SEQUOYAH FUELS CORPORATION
and GENERAL ATOMICS

(Gore, Oklahoma Site
Decontamination and
Decommissioning Funding)

Docket No. 40-8027-EA

REPLY AFFIDAVIT OF TIMOTHY P. BROWN

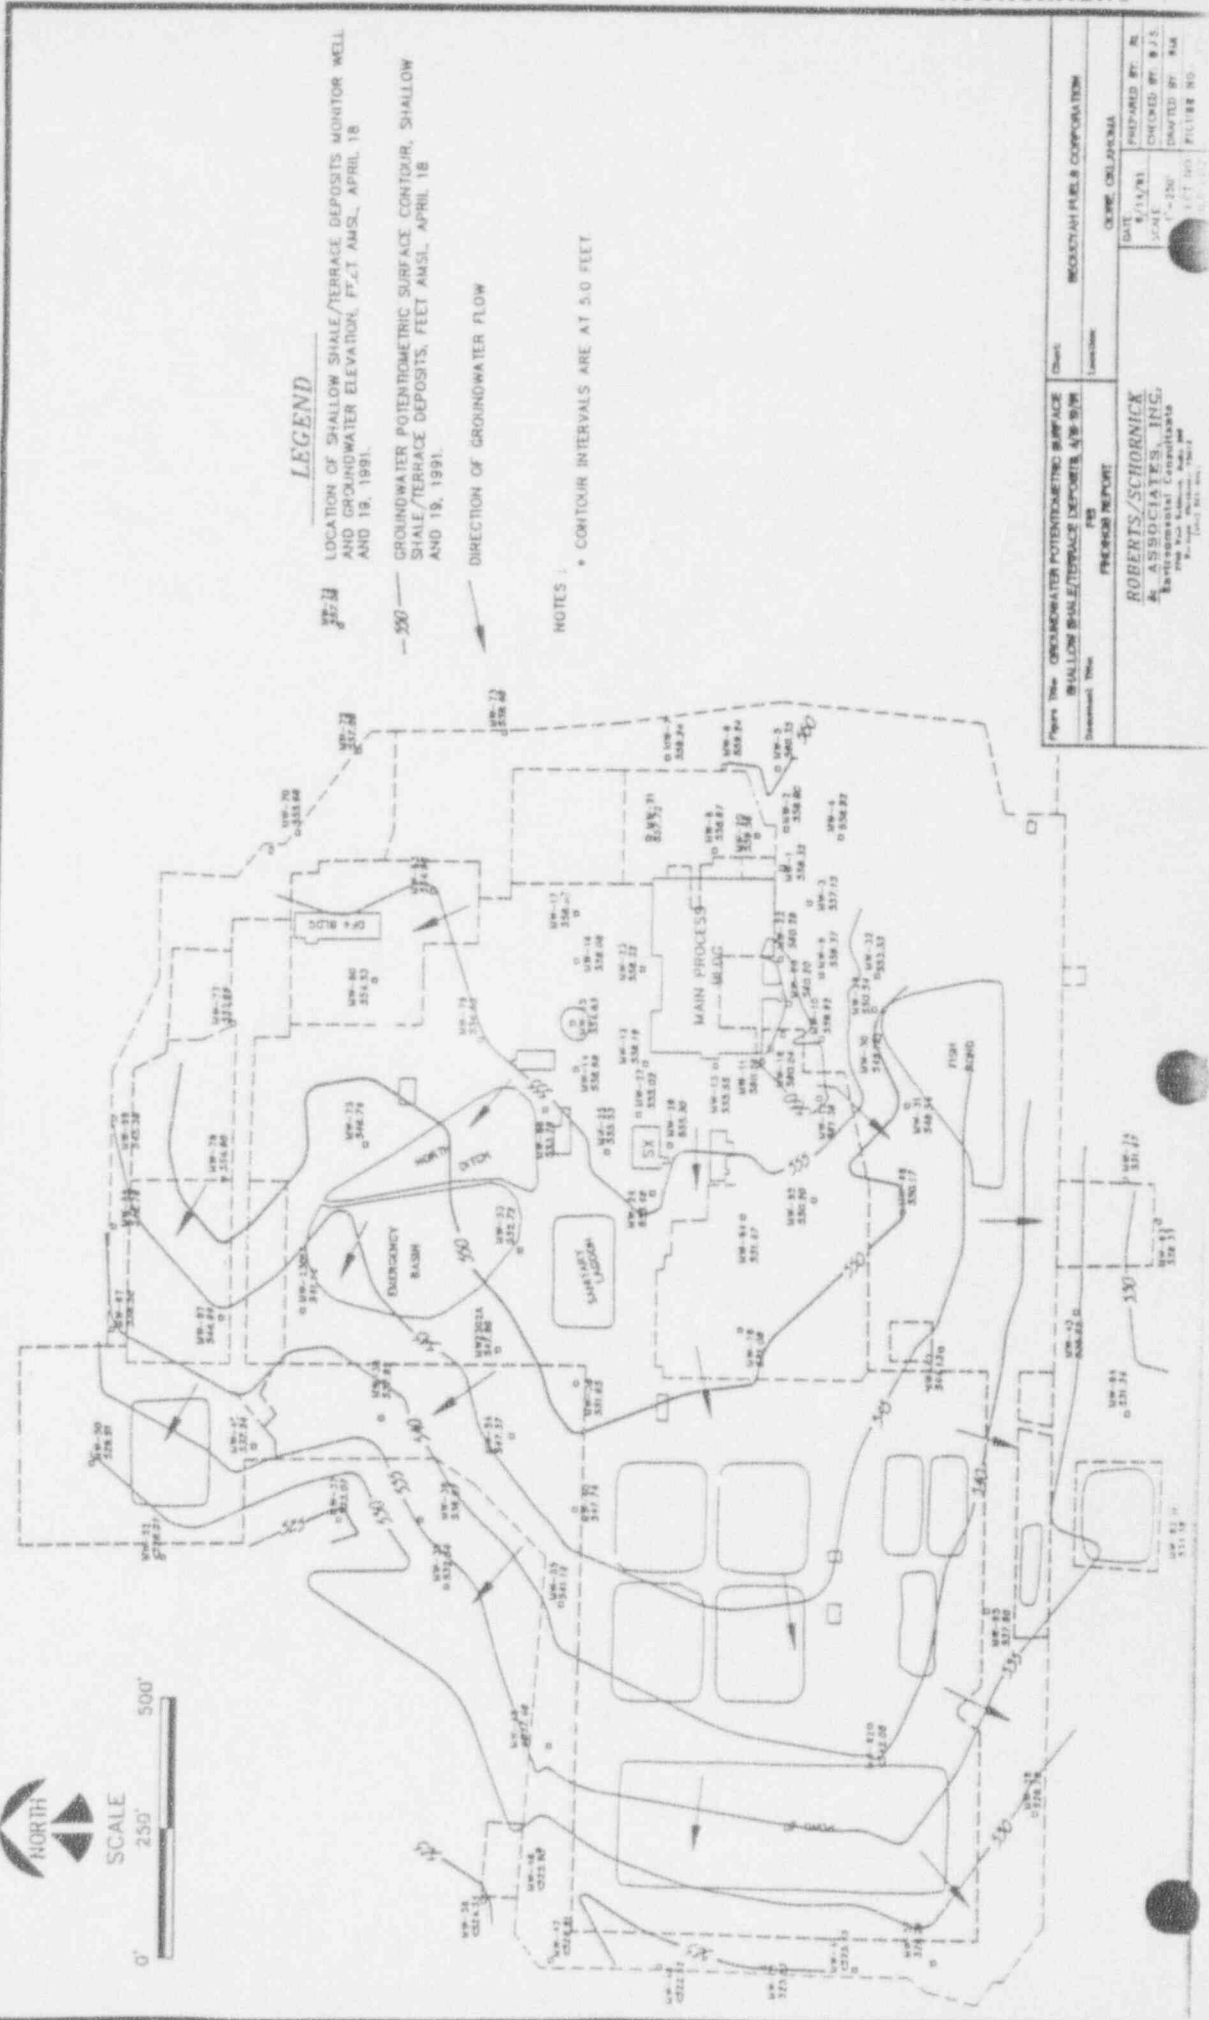
4) According to Mr. Smith, Attachments 3 and 4 of the Dietrich affidavit "show that the groundwater flow beneath the fertilizer pond area is generally westward and away from Mr. Henshaw's property." However, Attachments 3 and 4 do not support this assertion. First, they show groundwater flow in at least one other direction: in the southeast portion of the small area portrayed by these maps, flow is directed southerly. Second, as discussed in my previous affidavit at paragraph 7, these maps cover too small an area to reliably show groundwater flow in the entire area that potentially affects Mr. Henshaw's property. For instance, although the maps show groundwater flow in a southerly direction, it is impossible to tell what the flow field does south of the area. What little information is provided in Attachments 3 and 4 shows a rather complicated potentiometric surface. Thus, it is impossible to reliably predict where contaminants entering the groundwater will travel, based on this very small picture.

Figure No.	GROUNDWATER POTENTIOMETRIC SURFACE DEEP SANDSTONE/SHALE, 4/18-19/91	Client	BECKTAN PAPER CORPORATION
Drawn		Location	OCONE, OREGON
Checked		Prepared By	RL
Reviewed		Checked By	RJS
Approved		Drawn By	RL
		Scale	AS SHOWN
		Date	8/13/91
		Project No.	73

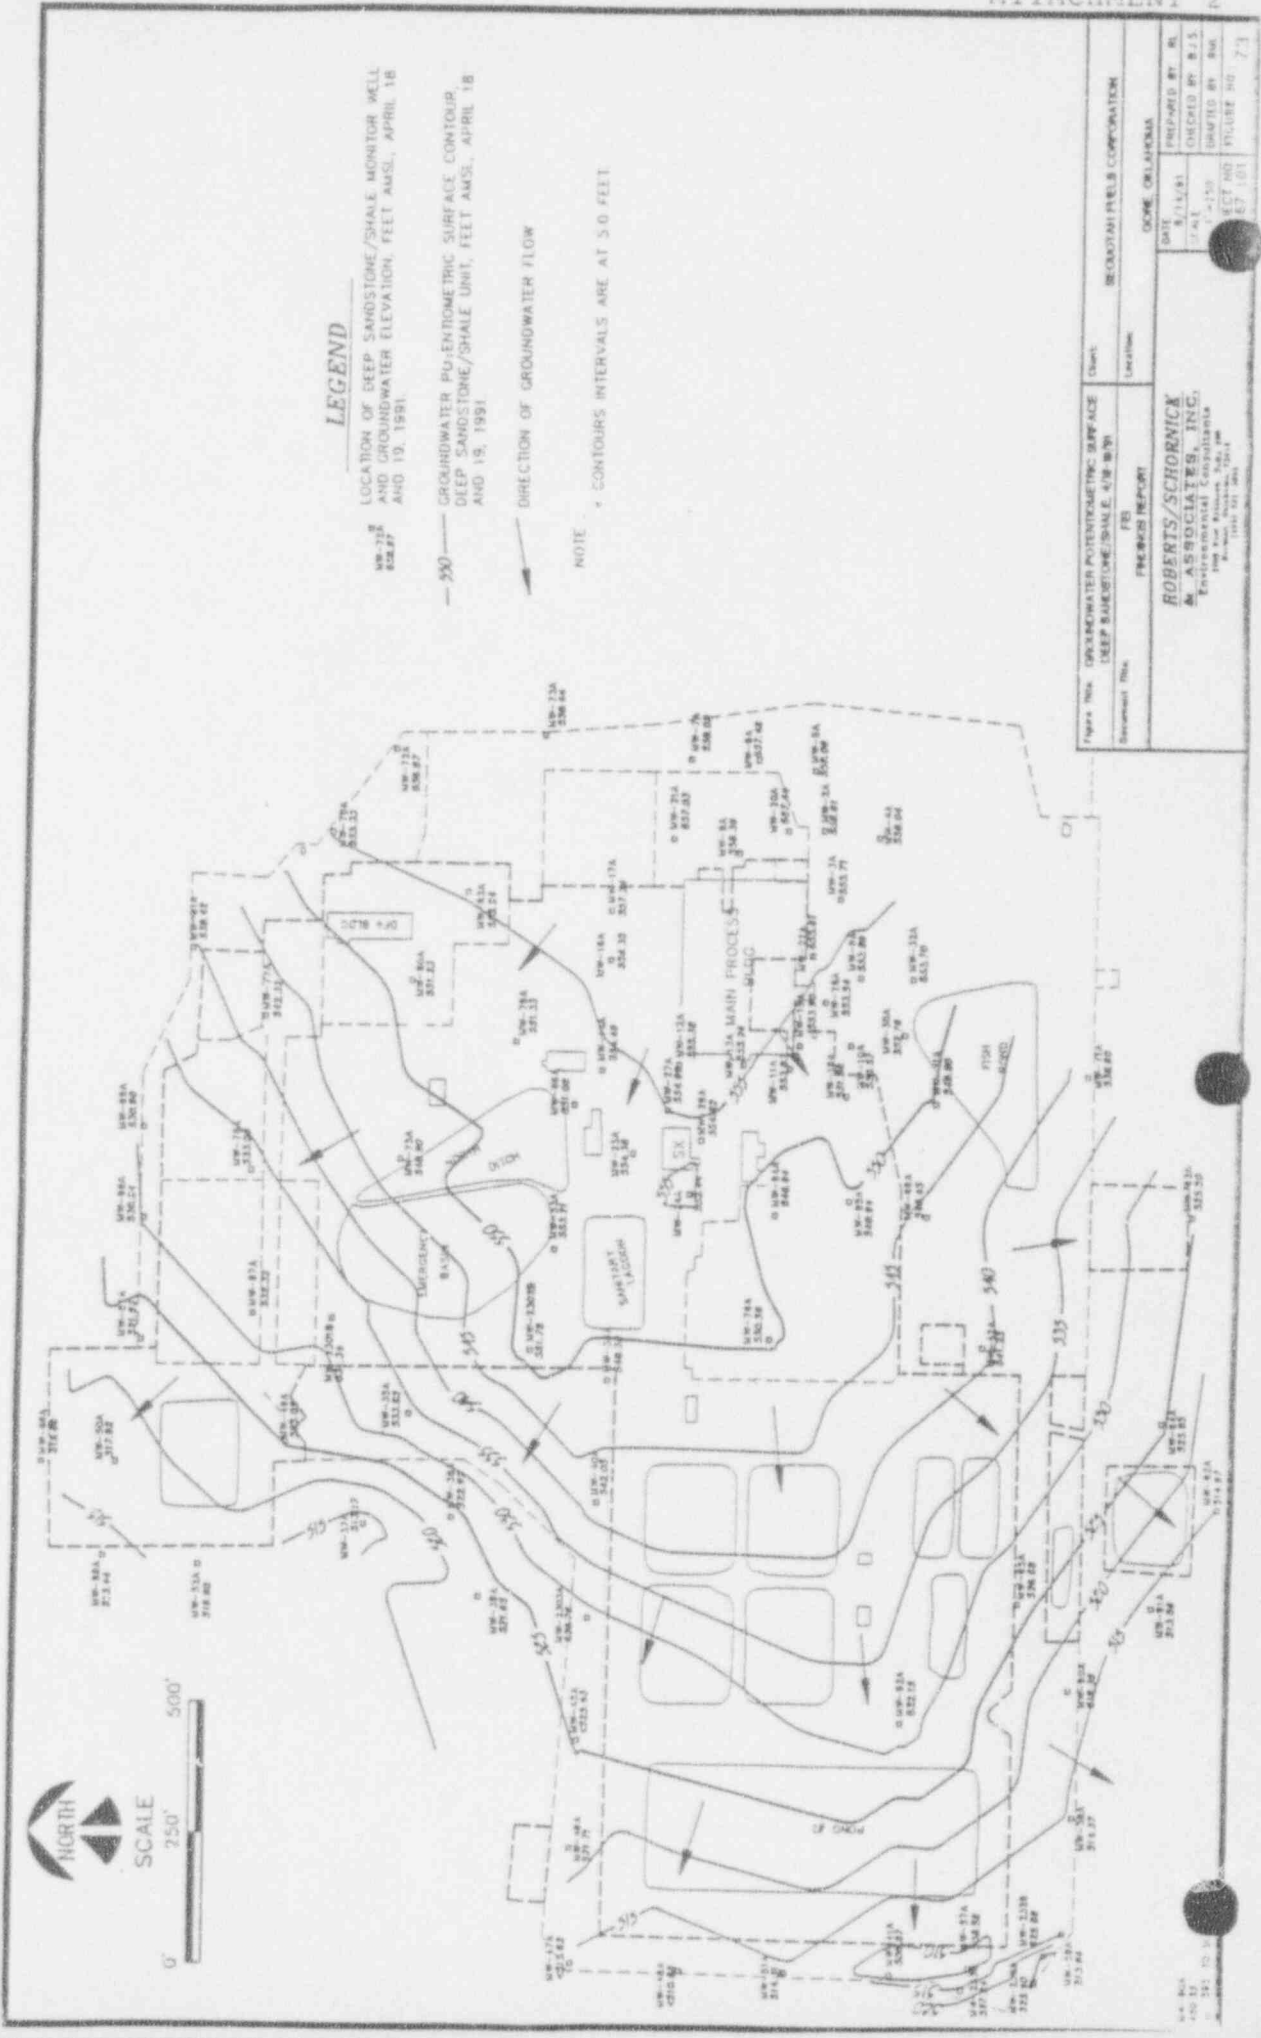
9) In my previous affidavit, I stated that Mr. Dietrich's affidavit failed to address the possibility that deeper levels of groundwater may flow toward Mr. Henshaw's property; and that none of SFC's reports provide any data for depths greater than 40-50 feet (paragraph 7(d)). Mr. Smith asserts in response that "The FEI and Addendum investigations showed that most of the contamination at the site was in the upper groundwater horizon (shallow shale/terrace) and generally lower levels of contamination occurred in the deeper sandstone/shale groundwater horizon (Attachments A-6 and A-7)." Accordingly, he states that "this information was sufficient to convince the investigators that the possibility of significant contamination in even lower zones was
